# Test Symbol Error Extrapolation

Addressing comments: 226 296 106

802.3dj interim

**Two related comments were submitted on Clause 180.9.15 on D3.0 with different solutions, the intent of this contribution is to facilitate comment resolution.**

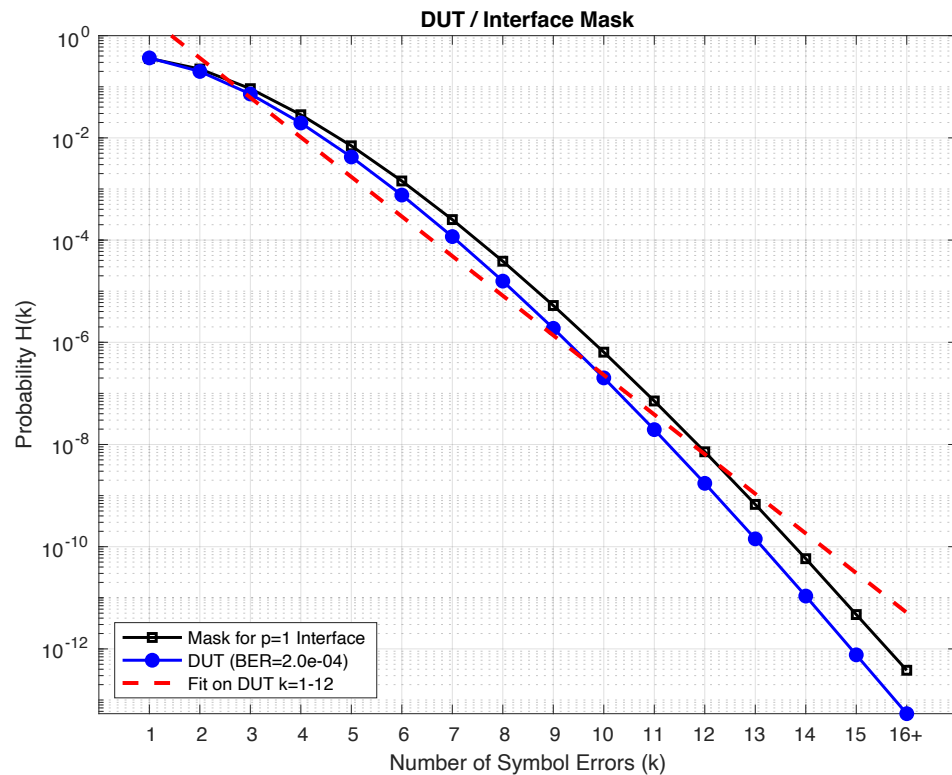
**ran\_3dj\_elec\_01\_240822 analyzed Symbol Error histograms with added Tx jitter versus LPF BW**

- With random errors the slope becomes steeper as bin count increases
- With added jitter the slope can become less steep as bin count increases

# Improved fitting

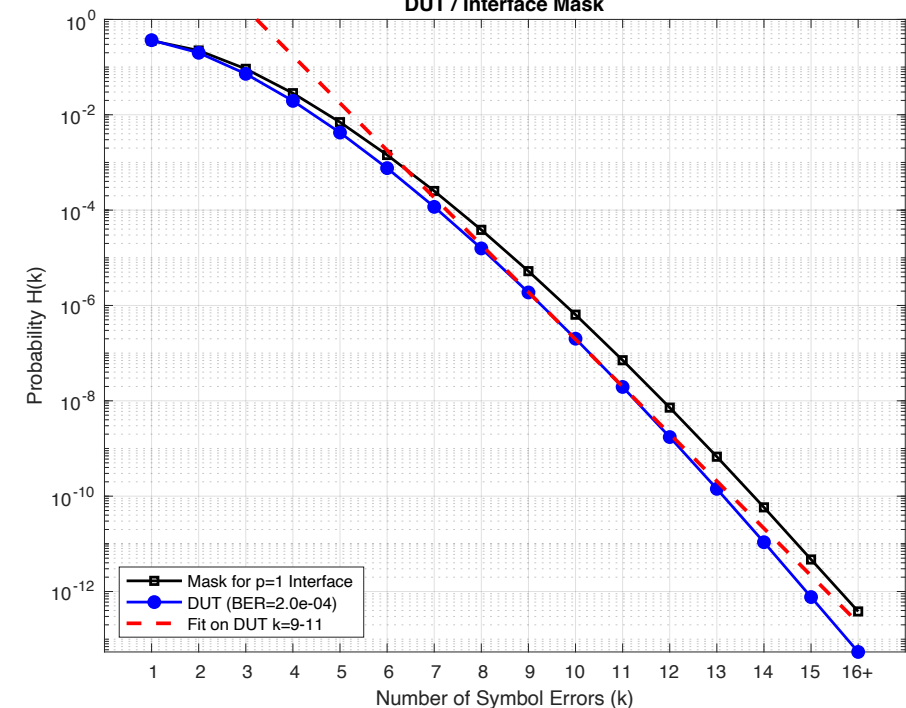
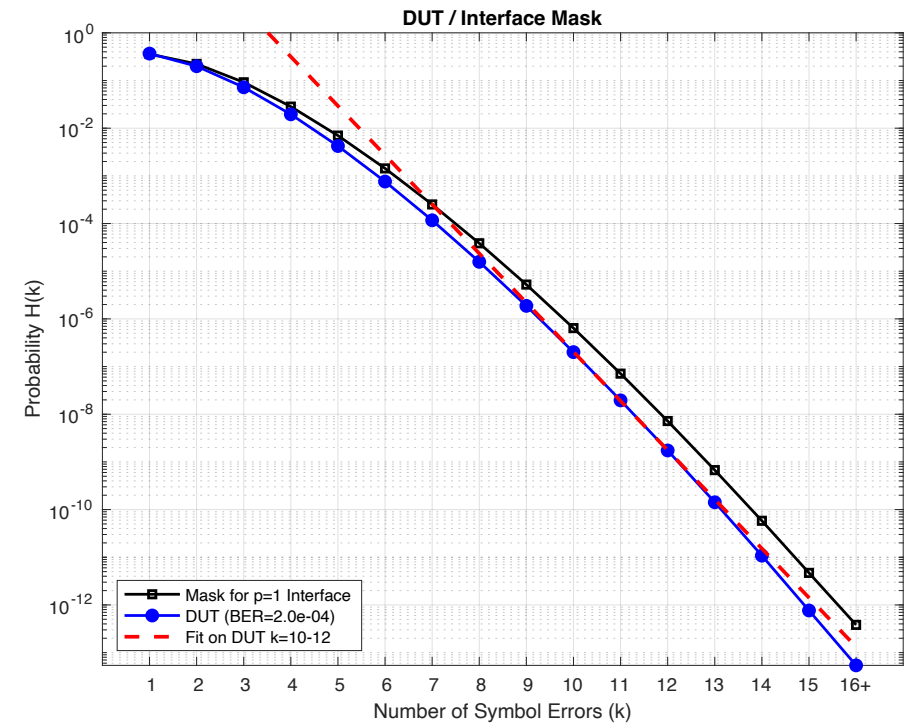
Only using the bins with the highest symbol errors for the extrapolation will improve the fit

For a BER of  $2e-4$  with random errors bin 12 has an expected count of 4 events

- Top: Fit using  $k = 10-12$ , based on bin 12 having  $> 2$  occurrences

- Fit on  $k= 9-11$ , since bin 12 has  $\approx 33\%$  probability of  $\leq 2$  counts

Both extrapolations are an improvement

- Using a criteria of 3 counts for the highest bin allows for more variability than is desirable

# Highest Bin statistical variation

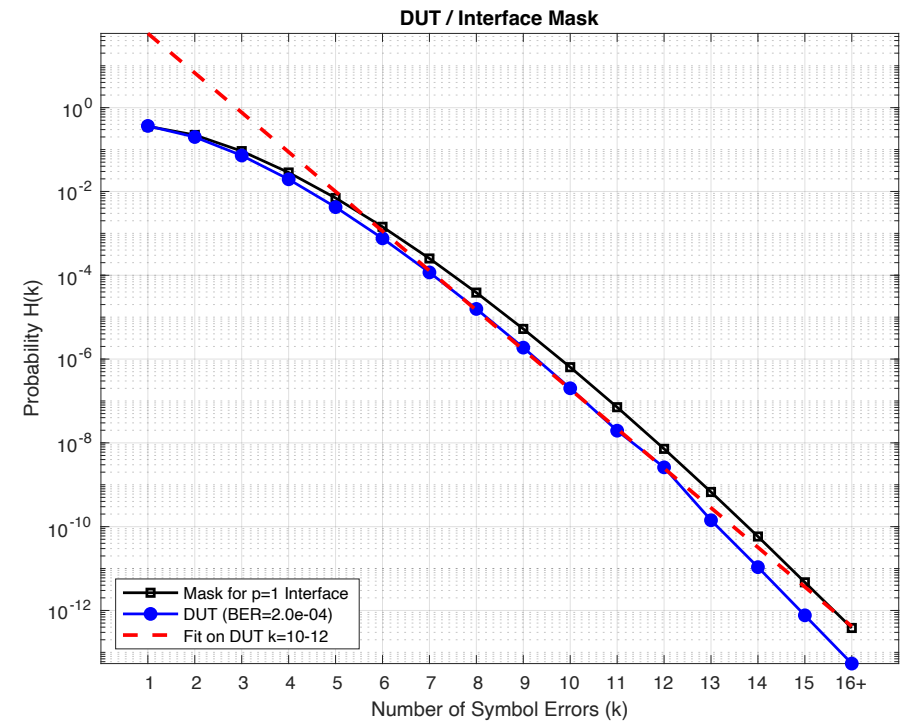
Because the points used in current definition are those with only 3 events, there will be variations in last point

On the right curves for a  $2E-4$  BER are shown, with bin 12 being a 10% probability (mean = 4,  $\geq 6$  counts  $\sim 12\%$  probability)

Using 3 counts in highest bin allows too much variability

Recommend truncating the data for extrapolation to  $> 9$  counts

# Impact of correlated errors

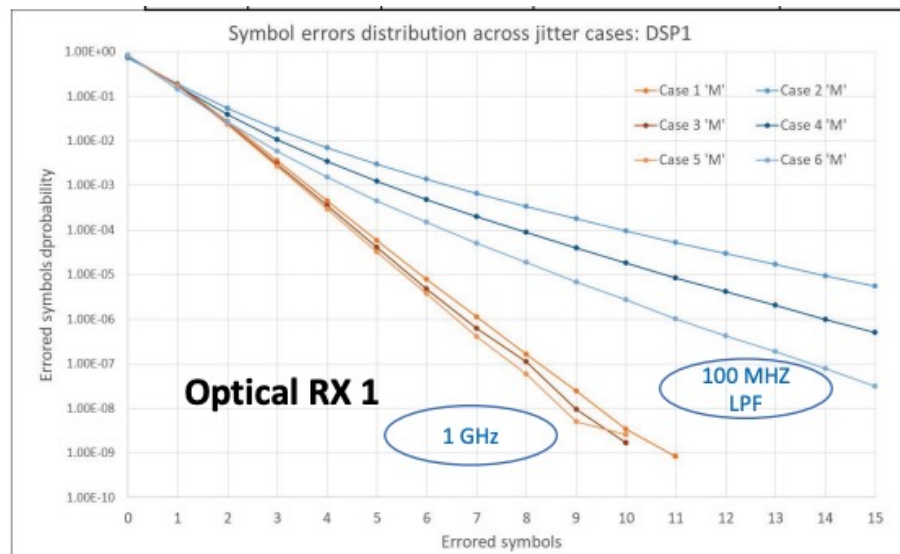
In ran\_3dj\_elec\_01a\_240822 the impact of correlated errors on the symbol error distribution is considered

The change in slope can be used to evaluate performance

Key message is that in addition to ensuring that the measured data extrapolates to meet the symbol error requirements at bin 16, it is also useful to check that increasing slope isn't going to cause a failure.
